Quectel Wireless Solutions Co., Ltd

Test Data Reuse Letter

SC20-ALD, FCC ID: **XMR2021SC20ALD** is the variant of certified **SC20-A** module.

The position of the different components in the PCB is shown in the follow picture

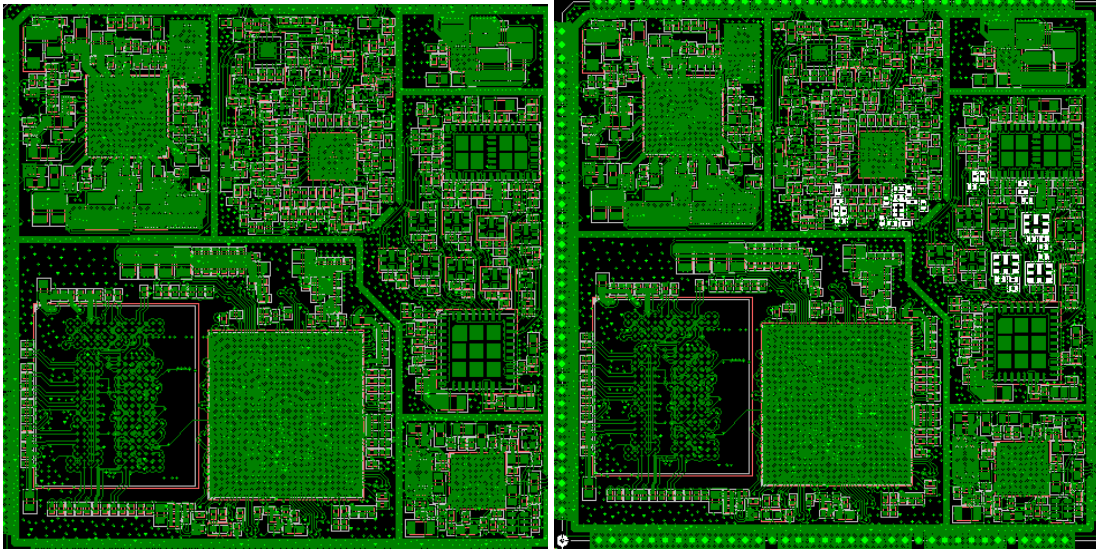
Here we remove some small RF components which used in WCDMA and GSM. Main RF components changes as follow table

Designator	SC20-A(part description)	SC20-AD(part description)	Notes
U1105	IC RF DPX UMTS/LTE UNBalance B4 1.8x1.4mm H0.5mm RO	NM	B4 Duplexer
L1148	IND HIGH HQ 3.9nH +/-0.1nH CH0201 RO	NM	inductor
L1147	IND HIGH HQ 6.8nH +/-3% CH0201 RO	NM	inductor
L1149	IND HIGH HQ 3.3nH +/-0.1nH CH0201 RO	NM	inductor
C1113	CAP C0G 22pF +/-5% 50V CH0201 RO	NM	capacitor
C1114	CAP C0G 0.5pF +/-0.1pF 50V CH0201 RO	NM	capacitor
L1141	IND HIGH HQ 12nH +/-3% CH0201 RO	NM	inductor
L1142	CAP C0G 12pF +/-5% 50V CH0201 RO	NM	capacitor
L1143	IND HIGH HQ 4.3nH +/-3% CH0201 RO	NM	inductor
L1144	IND HIGH HQ 8.2nH +/-3% CH0201 RO	NM	inductor
L1145	IND HIGH HQ 2.2nH +/-0.1nH CH0201 RO	NM	inductor
L1146	CAP C0G 0.5pF +/-0.1pF 50V CH0201 RO	NM	capacitor
U1108	IC RF SWITCH SPDT 35dBm 1.1x0.7mm H0.32mm RO	NM	SWITCH
U1104	IC RF DPX UMTS/LTE UNBalance B1 1.8x1.4mm H0.6mm RO	IC RF DPX UMTS/LTE UNBalance B4 1.8x1.4mm H0.5mm RO	B1 Duplexer
L1129	IND HIGH HQ 6.8nH +/-3% CH0201 RO	NM	inductor

U1006	IC RF DPX UMTS/LTE UNBalance B8 1.8x1.4mm H0.5mm RO	NM	WB8 Duplexer
L1026	IND HIGH HQ 10nH +/-3% CH0201 RO	NM	inductor
C1020	IND HIGH HQ 2.2nH +/-0.1nH CH0201 RO	NM	inductor
L1027	IND HIGH HQ 1.0nH +/-0.1nH CH0201 RO	NM	inductor
L1014	IND HIGH 27nH +/-5% CH0201 RO	NM	inductor
L1015	IND HIGH HQ 18nH +/-3% CH0201 RO	NM	inductor
C1013	CAP C0G 100pF +/-5% 50V CH0201 RO	NM	capacitor
C1101	CAP C0G 22pF +/-5% 50V CH0201 RO	NM	capacitor
C1102	CAP C0G 22pF +/-5% 50V CH0201 RO	NM	capacitor
R1102	NM	CAP C0G 22pF +/-5% 50V CH0201 RO	
R1103	NM	CAP C0G 22pF +/-5% 50V CH0201 RO
